SUBJECT: Duke Energy Corporation  
Oconee Nuclear Station, Unit 3, Docket Nos. 50-287  
McGuire Nuclear Station, Unit 2, Docket No. 50-370  
Catawba Nuclear Station, Units 1 & 2, Docket Nos. 50-413, 50-414

Response to Request for Additional Information  
Relief Request 04-GO-002  
(TAC NOS. MC3804, MC3805, MC3807, MC3810)

Catawba Unit 2 Reactor Pressure Vessel  
Flange-to-Upper Shell Weld

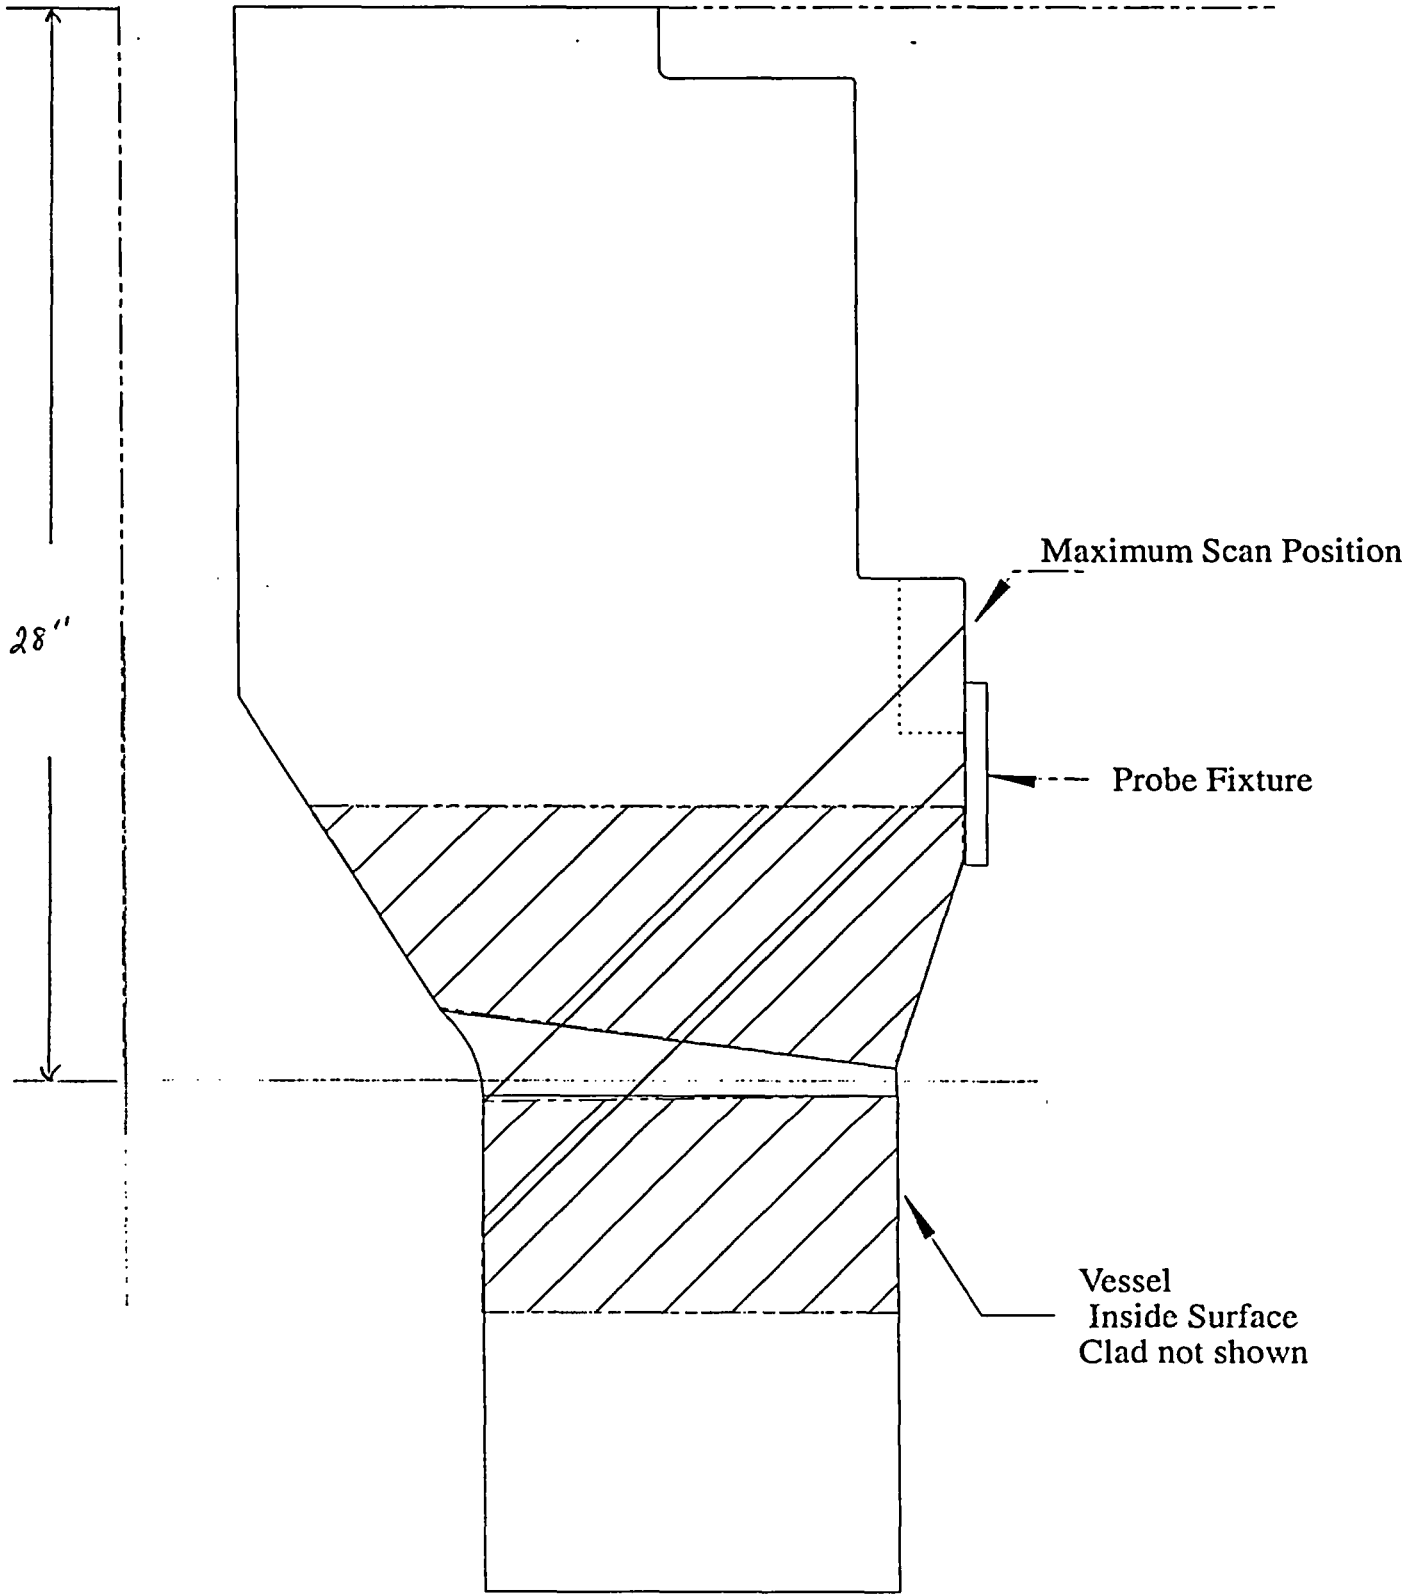
- a. Catawba Unit 2 = 90.5%
  - b. McGuire Unit 2 and Catawba Unit 1 = 90.5%
  - c. Oconee Unit 3 = 72.6%
3. Provide drawings of the RPV Upper Shell to Flange and its weld for the affected units.

Drawings showing the Flange-to-Upper Shell Welds at each unit are attached as follows: Attachment 1, Catawba Unit 2 Reactor Pressure Vessel Flange-to-Upper Shell Weld, Attachment 2, CNS-1, MNS-2 Flange-to-Upper Shell Weld and Attachment 3, Oconee Unit 3 Reactor Pressure Vessel Flange-to-Upper Shell Weld.
